NATIONAL TRANSPORTATION SAFETY BOARD WASHINGTON, D.C.

SAFETY RECOMMENDATION(S)

H-77-7 and 8

Views of stone barrier on the George Washington Memorial Parkway.

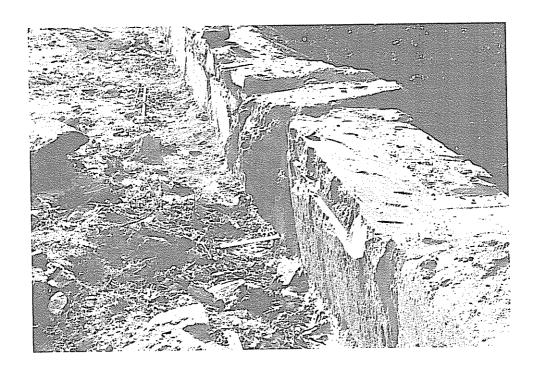
The NPS recently repaired an earth retaining wall that also serves as a traffic barrier on the parkway about one-half mile north of the Key Bridge. The surface of the barrier on the traffic side has been faced with rough and irregular stone. The stone facing was completely removed during the repair and subsequently replaced. The face contains snags of heavy stone that are as much as 6 inches deep and which would contact the side or bumpers of any car which moves 5 feet beyond the normal path of travel. (See photographs) There are other locations with similar barriers. The Board believes that these snags are a hazard not consistent with accepted standards and guidelines for barrier faces, such as those adopted by the Federal Highway Administration (FHWA). Also, measurements of the barrier indicate that its finished height might not comply with minimum FHWA requirements.

A rough surface can increase substantially the severity of an impact between a vehicle and barrier by either causing the vehicle to snag and spinout or by substantially increasing vehicle property damage with a potentially hazardous result to vehicle occupants. The rough surface also enhances the ability of a vehicle to override the barrier; this is particularly true for larger vehicles such as buses. There was no apparent effort made to update the barrier to improve its safety performance.

> Request the assistance of the Federal Highway Administration in developing attractive and performance-designed and evaluated traffic barriers that minimize hazards to vehicle occupants when the barriers are struck by passenger vehicles or buses. (Class II, Priority Followup) (H-77-7)

Upon completion of the traffic barrier research, implement a program to improve existing and future roadside barriers under jurisdiction of the National Park Service consistent with the newly developed designs. (Class II, Priority Followup) (H-77-8)
